Staff Report & Recommendation

Historic Preservation Board

HPB20-0388, 1116 Ocean Drive.

An application has been filed requesting an after-the-fact Certificate of Appropriateness for the installation of a canopy structure at the ground level.

1116 Ocean Drive photograph, Sheet A-18 from applicant's plans

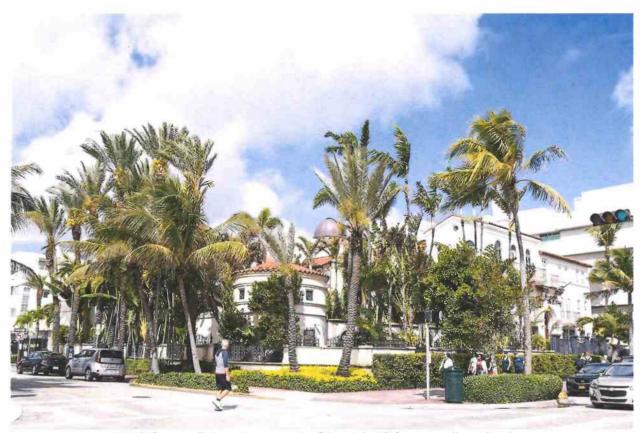
The applicant is currently requesting after-the-fact approval for the installation of a freestanding 28'-6" wide, 55'-6" long and 15'-0" tall canopy structure within the pool deck area. The canopy previously proposed in this area, and later withdrawn, was significantly larger (43'-0" by 70'-0" by 27'-6") and was attached to the existing building.

Staff initially expressed concern relative to the potential visibility of a canopy structure as viewed from Lummus Park. However, after visiting the site, staff does not believe the canopy with a retractable roof will have any adverse impact on the existing building or surrounding historic district. In this regard, the canopy is separated approximately 18'-0" from the contributing building and is setback over 33'-0" from the Ocean Drive property line. Additionally, as viewed from Ocean Drive, the canopy is almost entirely obscured by the existing site walls and landscaping. Finally, the canopy is minimally attached to the pool deck area and could very easily be removed in the future. As such, staff has no objection to the after the fact application.
